## TEXAS COMMISSION ON ENVIRONMENTAL QUALITY

Re: Edwards Aquifer, Comal County  
NAME OF PROJECT: **Guadalupe River Club Unit 2**; Located approximately 1600 feet east of FM 2673 and FM 306 intersection, approximately 500 feet on the north side of FM 306; near Sattler, Texas  
TYPE OF PLAN: Request for Approval of a **Contributing Zone Plan (CZP)**; 30 Texas Administrative Code (TAC) Chapter 213 Subchapter B Edwards Aquifer  
Edwards Aquifer Protection Program ID No. 2839.00; Investigation No. 704305; Regulated Entity No. RN105628630

**CONTRIBUTING ZONE PLAN  
COMMENT RESPONSE TO TCEQ  
COMMENTS NOVEMBER 21, 2008**

Guadalupe River Club-Unit 2 Comments and Responses to Contributing Zone Plan  
Comal County, Texas

**CONTRIBUTING ZONE PLAN  
ATTACHMENT I**

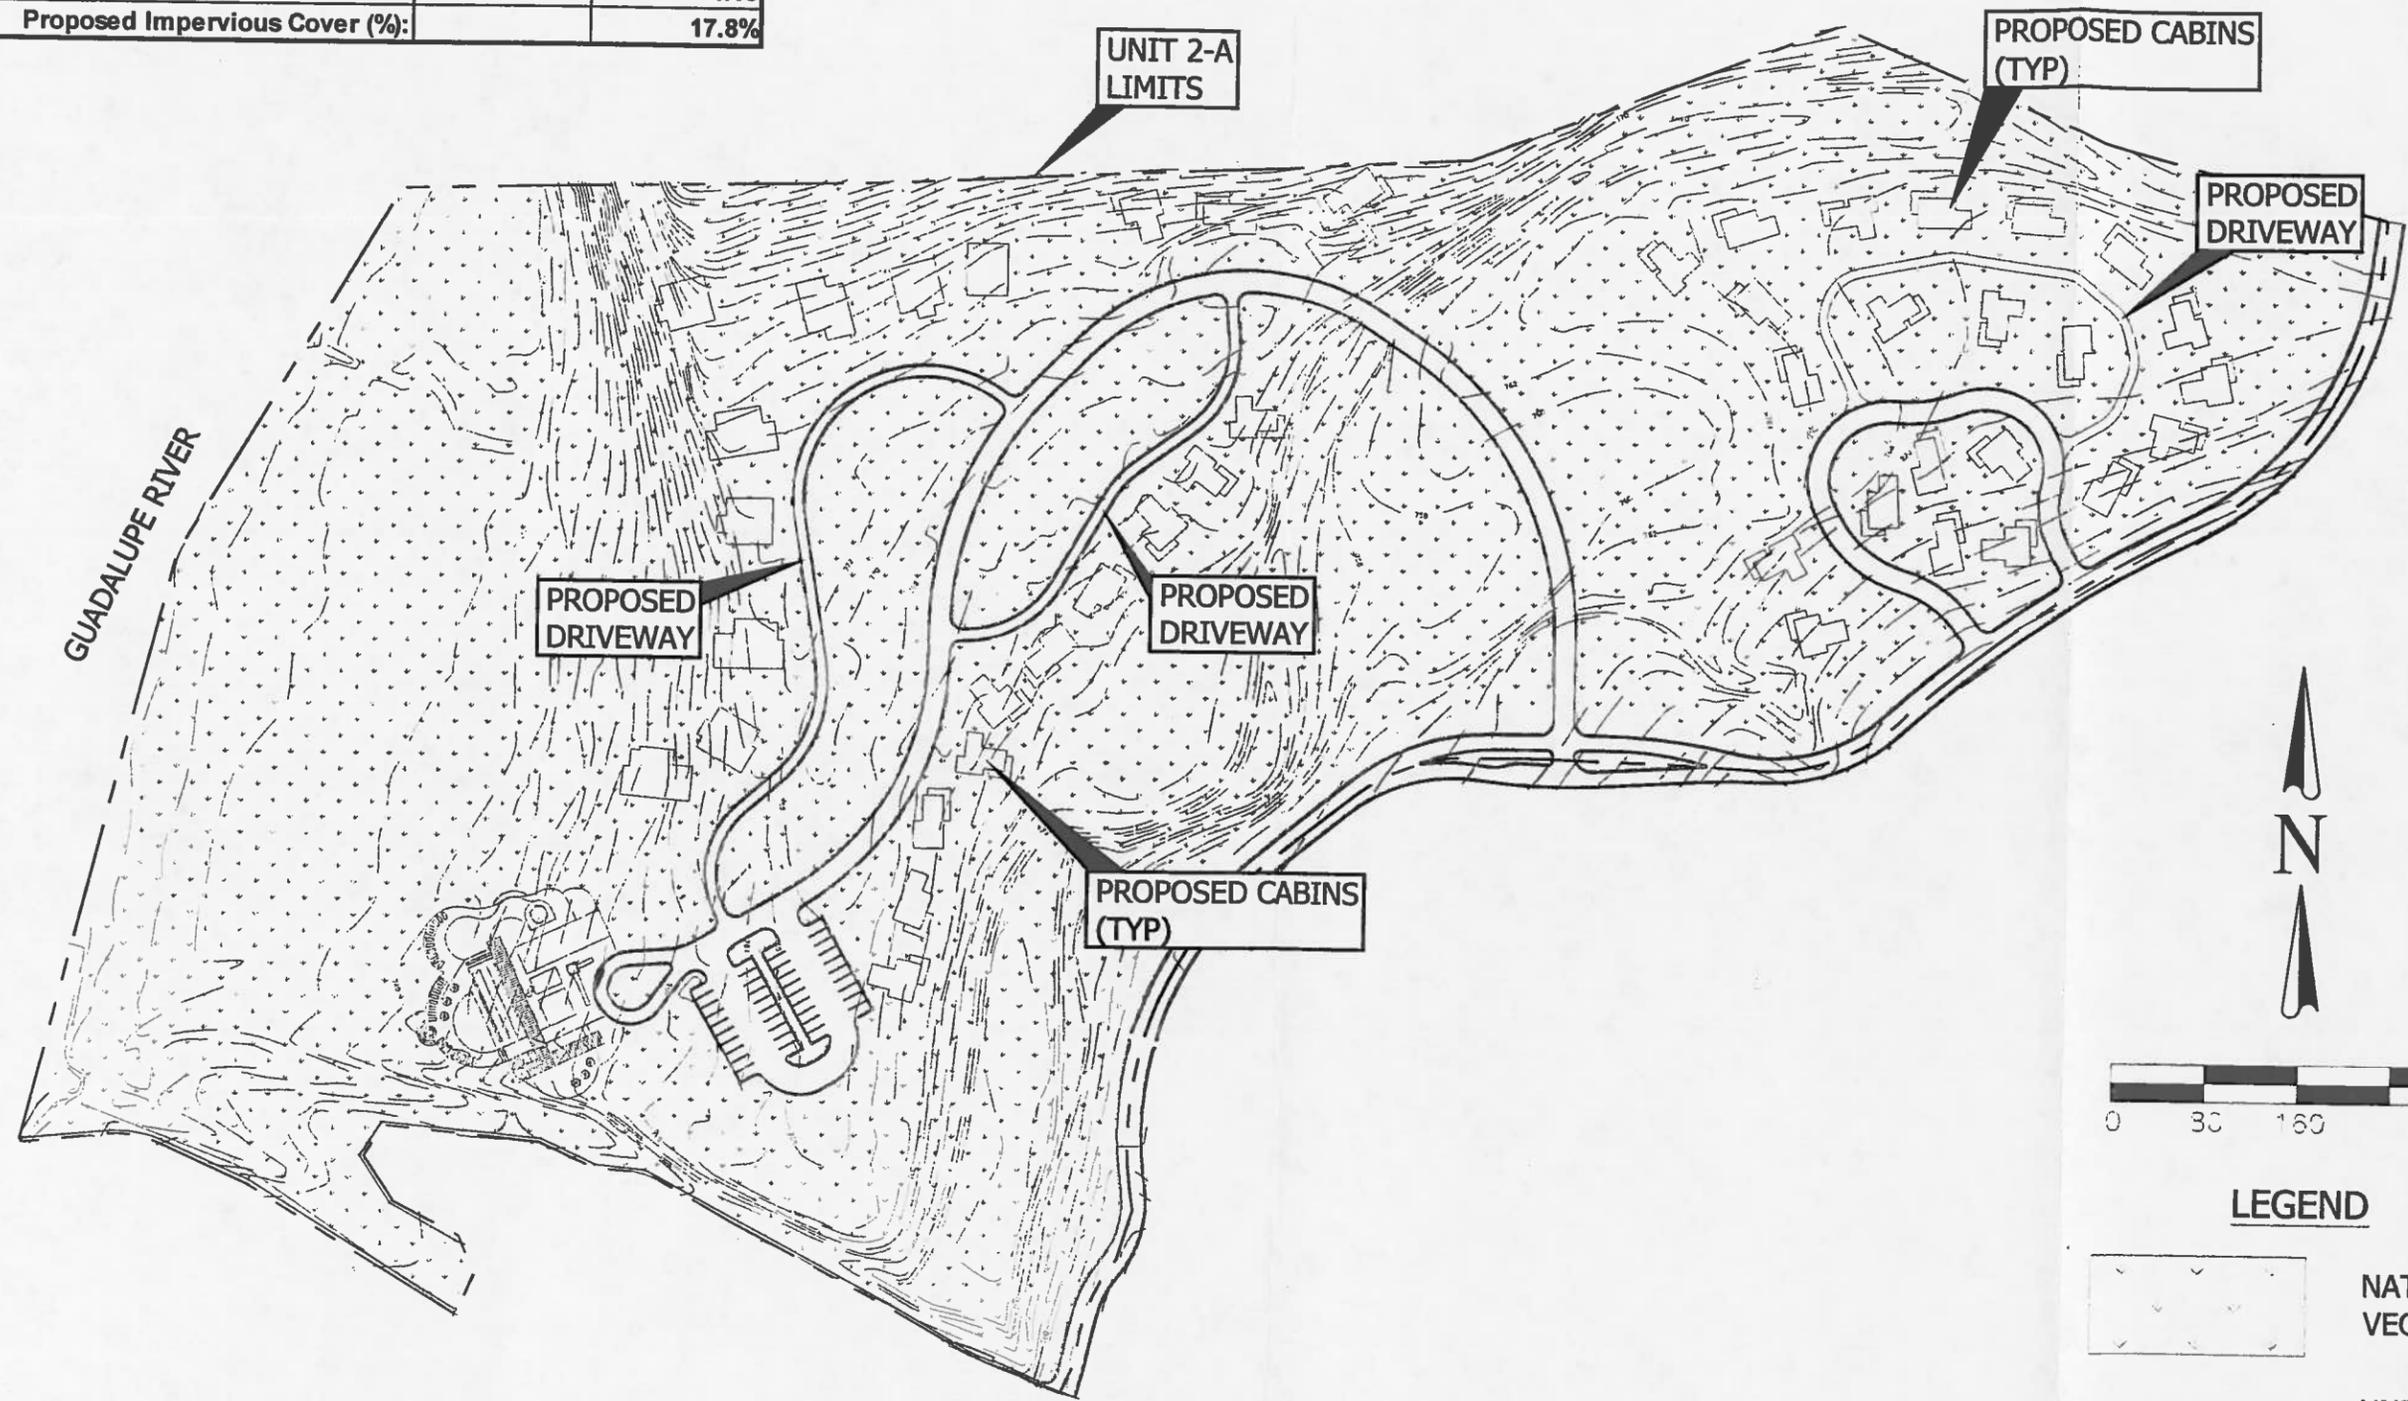
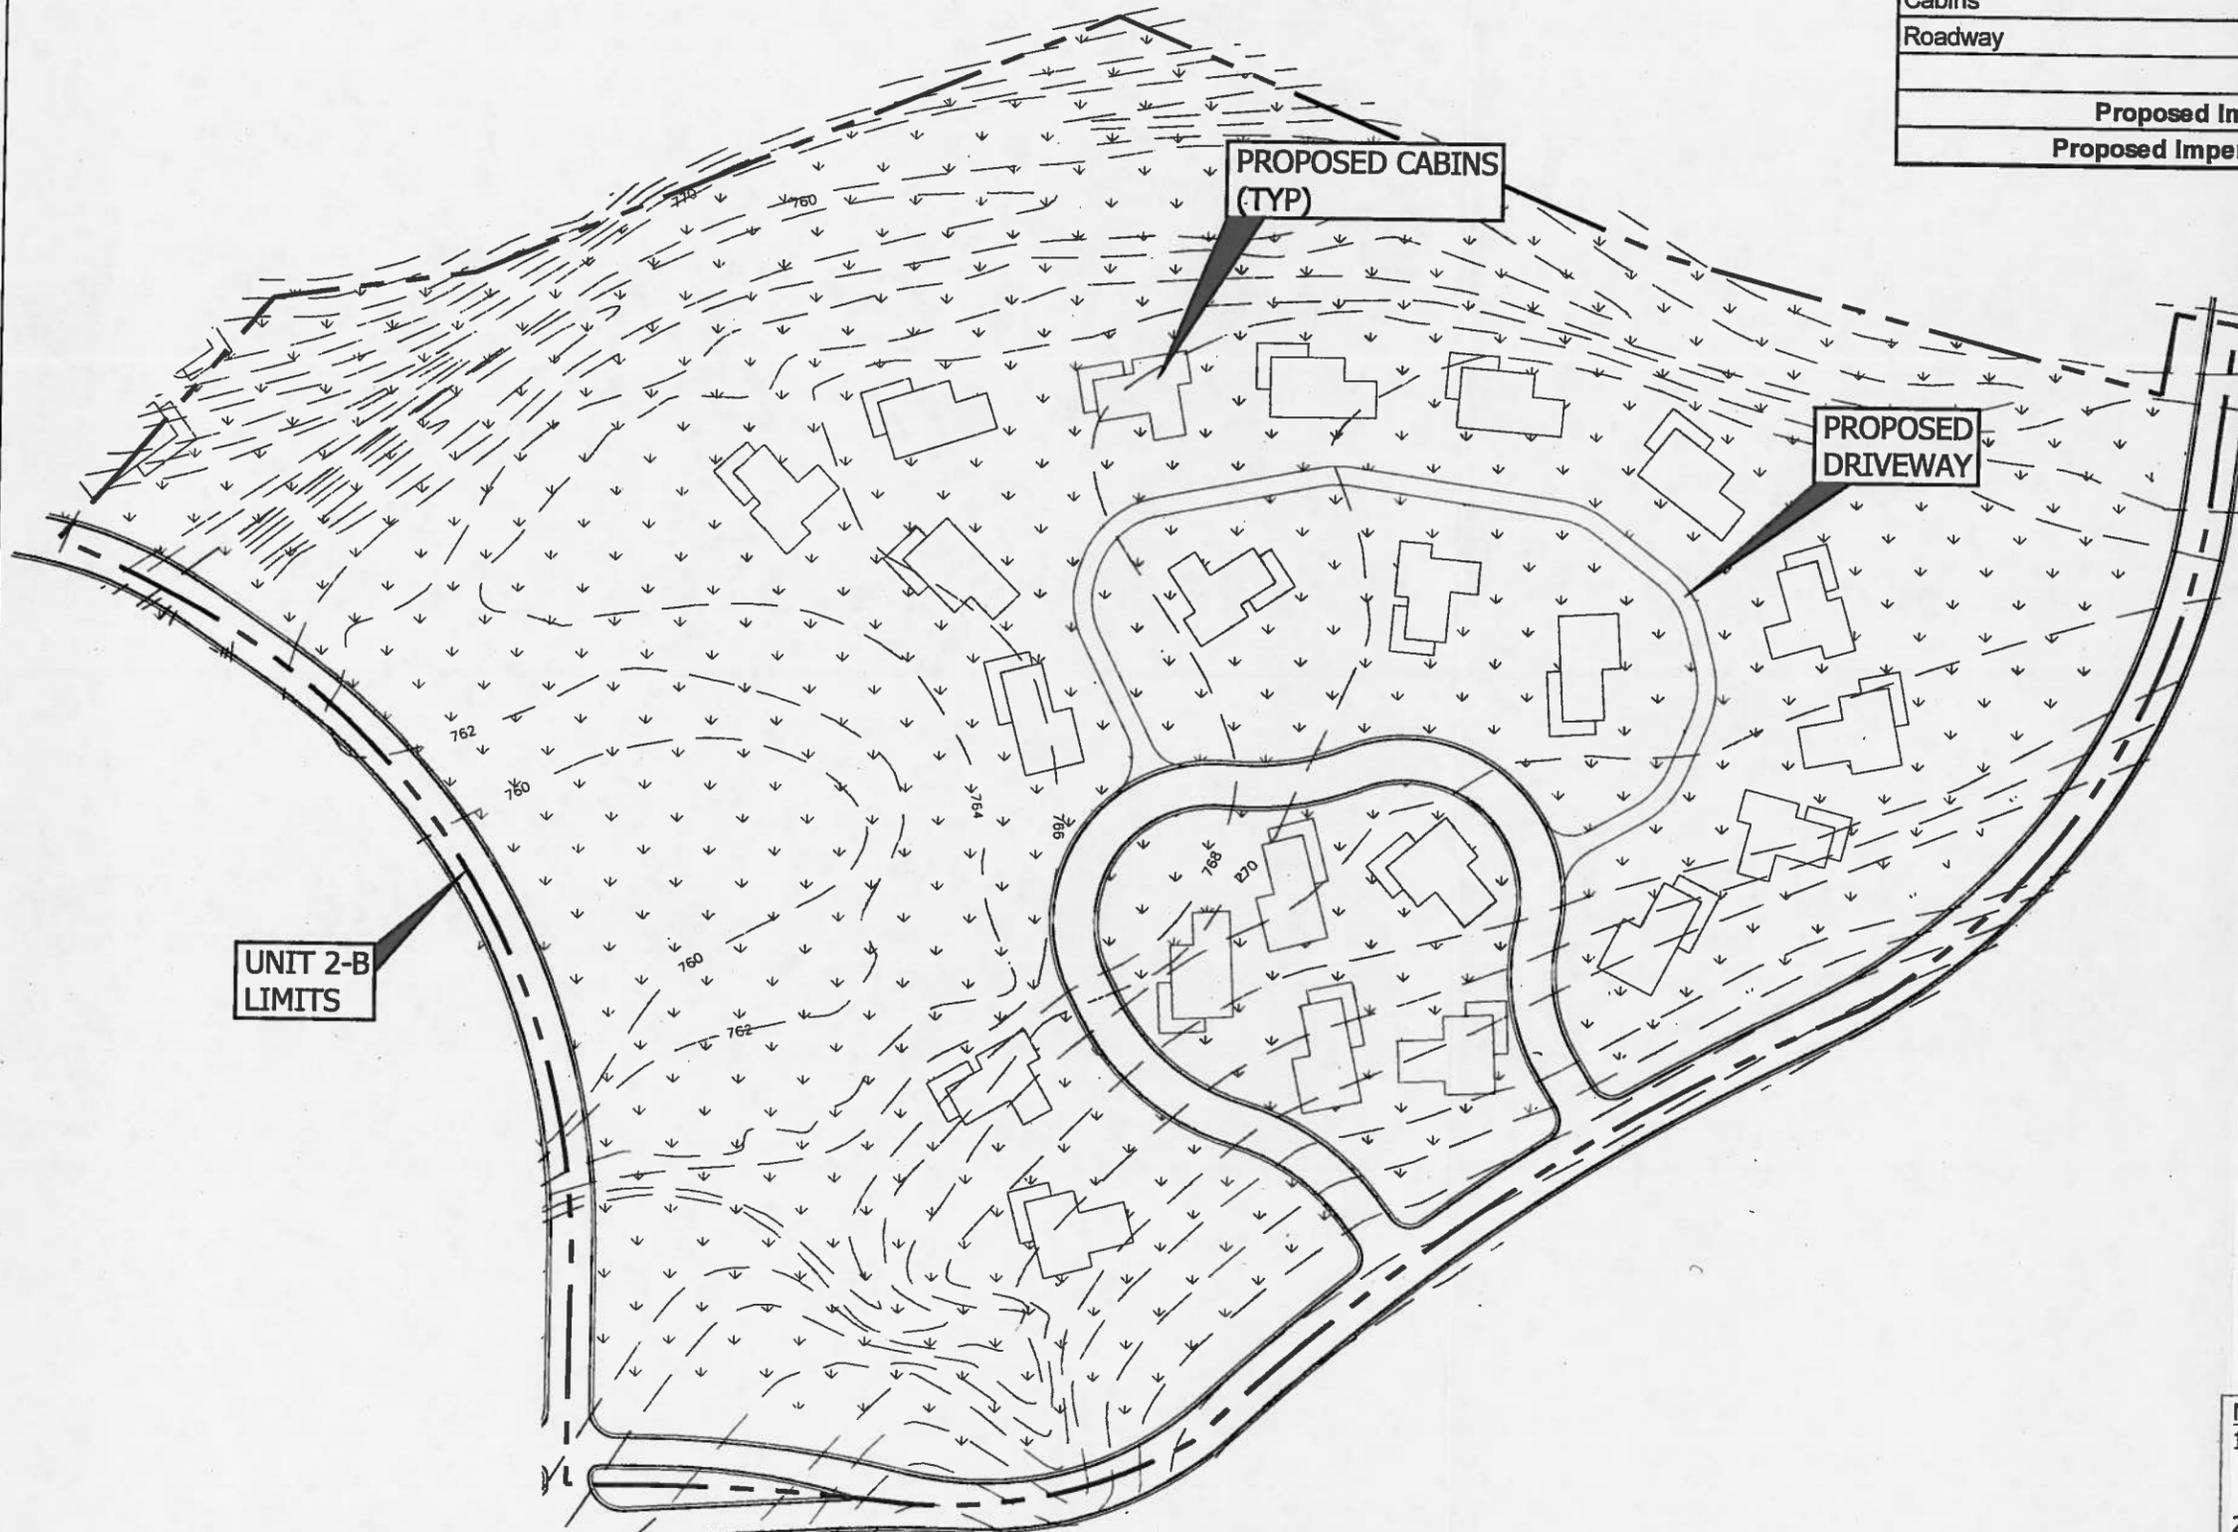
#35 Please detail on the site plan areas of soil disturbance and areas which will not be disturbed.

6. How will access be provided to the town homes? Please note that all of the structures proposed for the development need to be included on the site plan.

***The attached site plan has been adjusted to illustrate this better. Basically, the main roadways and driveways and their respective rights of way will be disturbed, but the area beyond the pavement will be reseeded. It is the intent of this project to keep grades as existing as much as possible, unless a road must be flattened more to keep acceptable roadway grades. We also assumed a distance into the lots to be disturbed.***

***We would like to note that these "homes" are cabins and not town homes. Town homes normally contain joint parking lots whereas, our cabins will all have private driveways that will provide access. There will be one common driveway leading to all cabins. This drive can be seen in the site plan exhibit, section 1.***

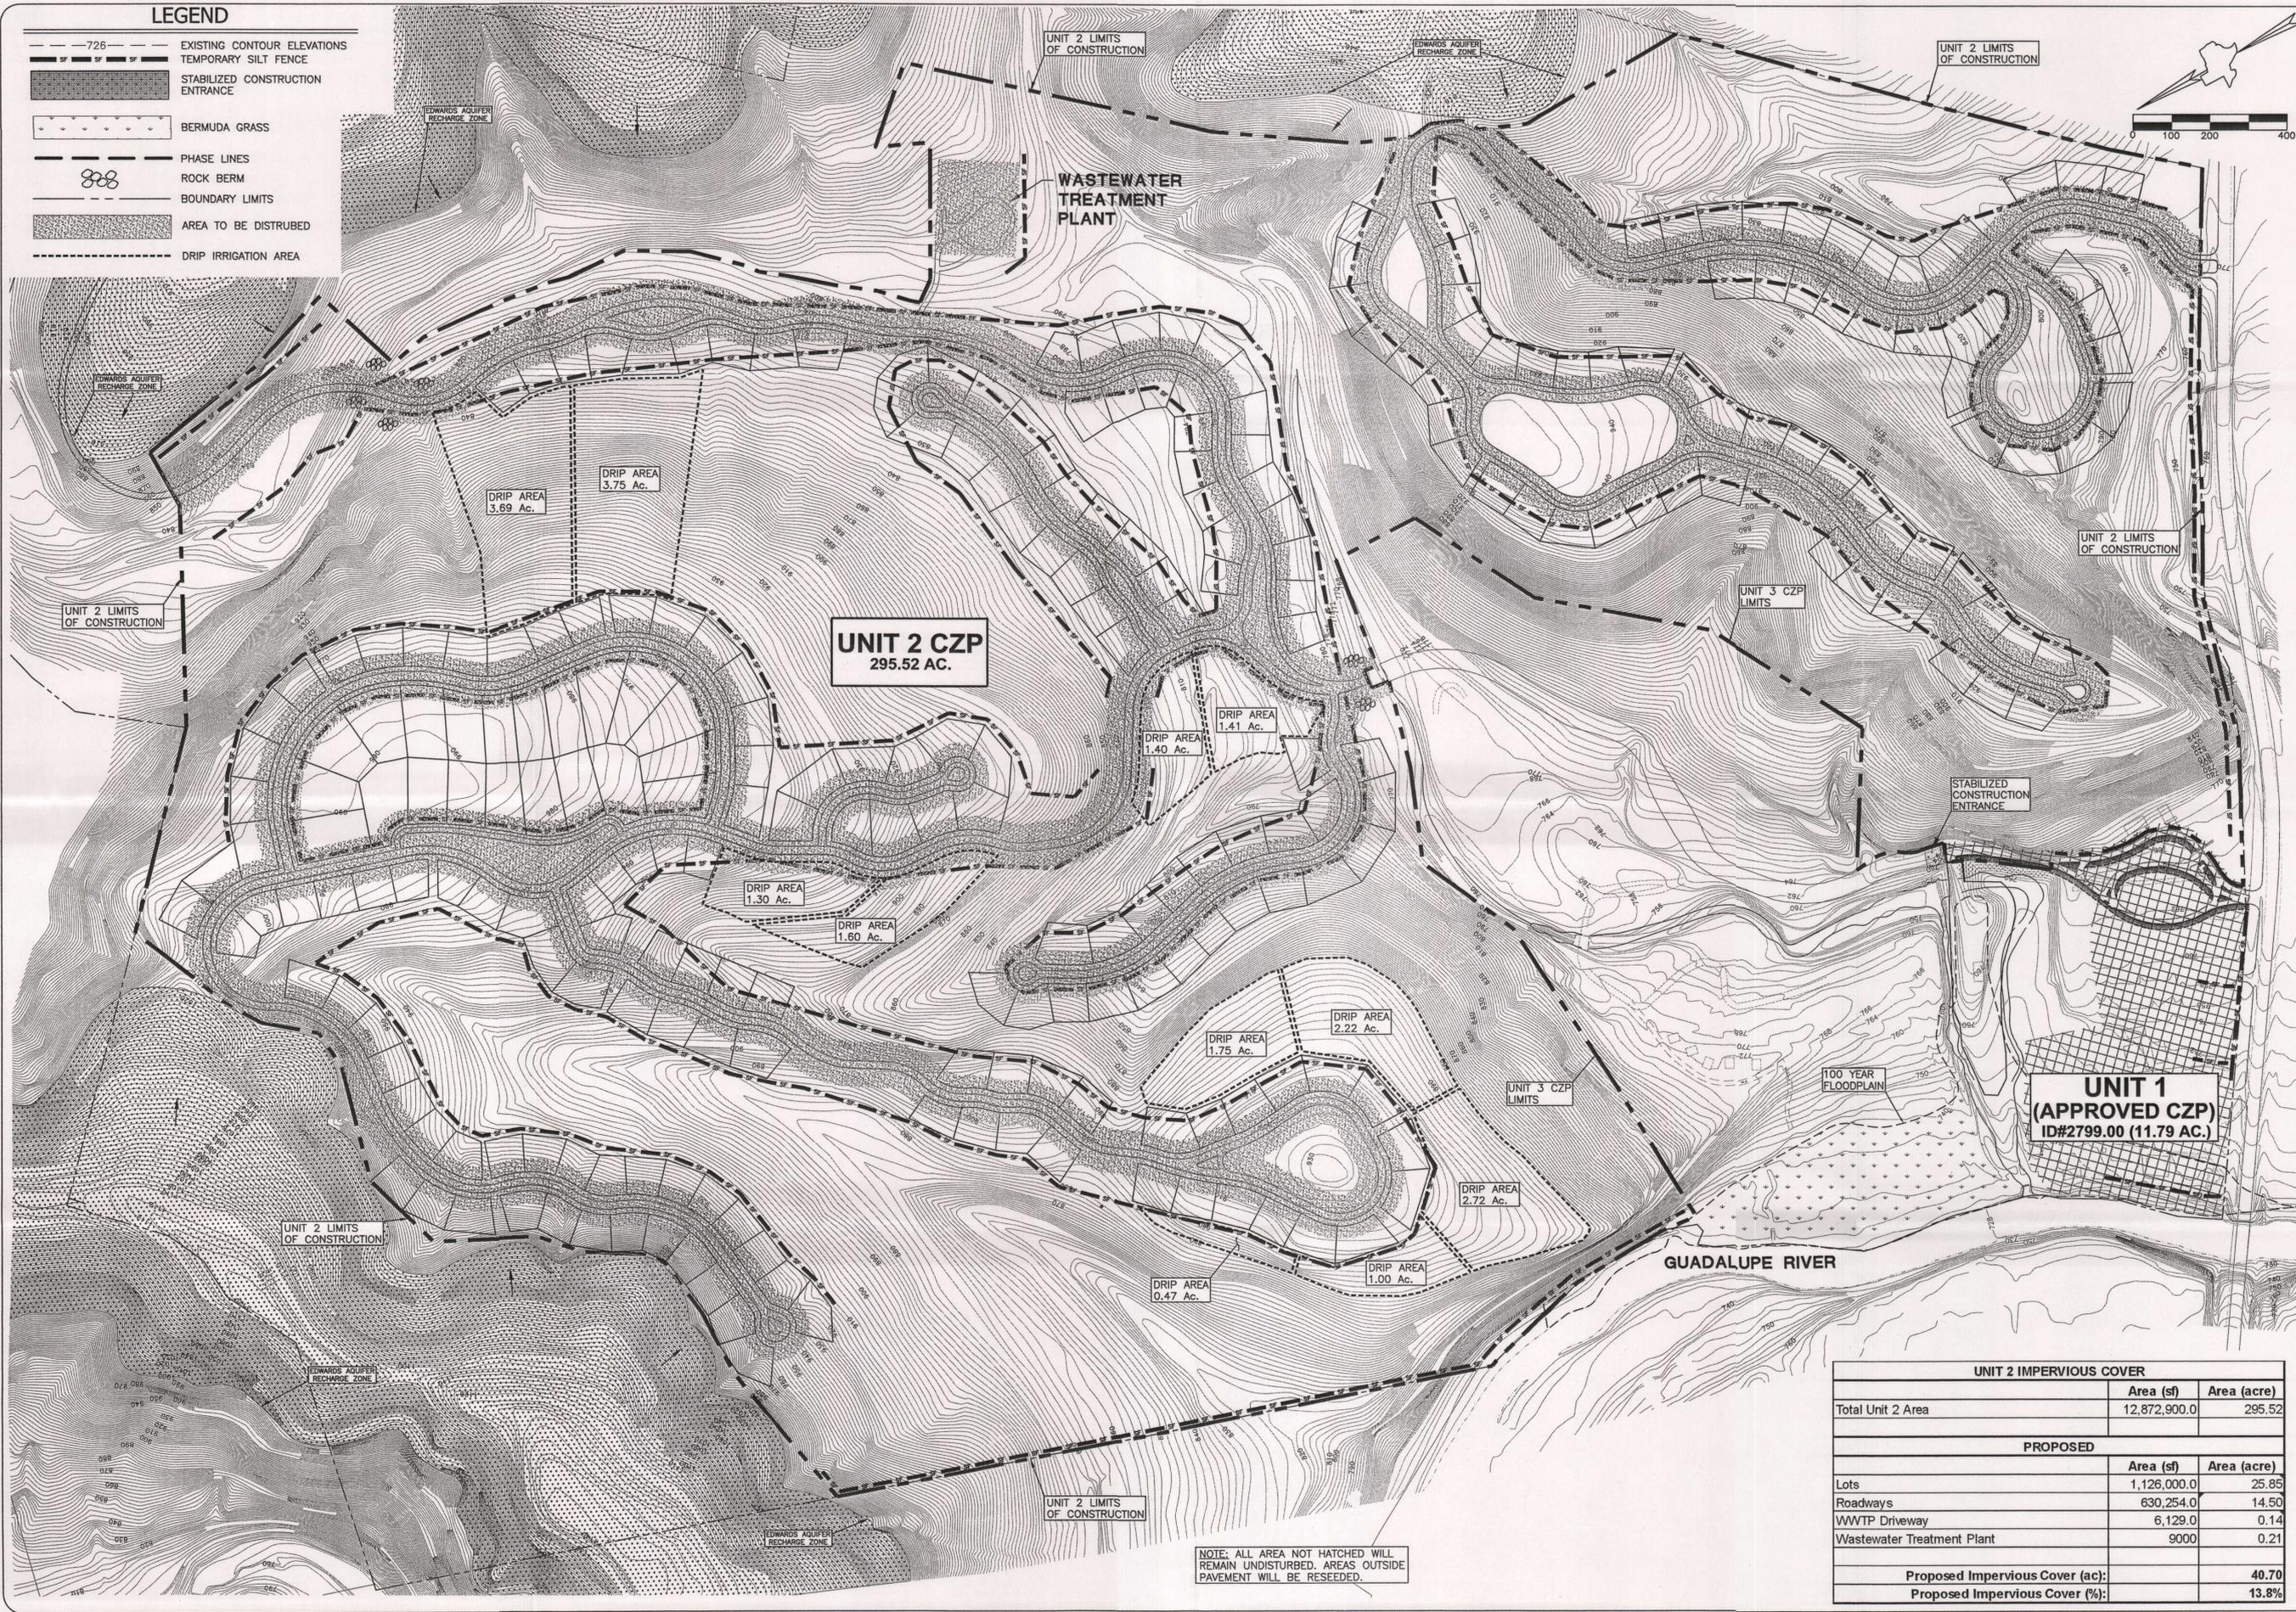
1. Please show all the areas of disturbance at the site (including areas for the wastewater treatment system installation throughout the site).

4. Has the impervious cover from the wastewater treatment plant been included in the total impervious cover calculation?
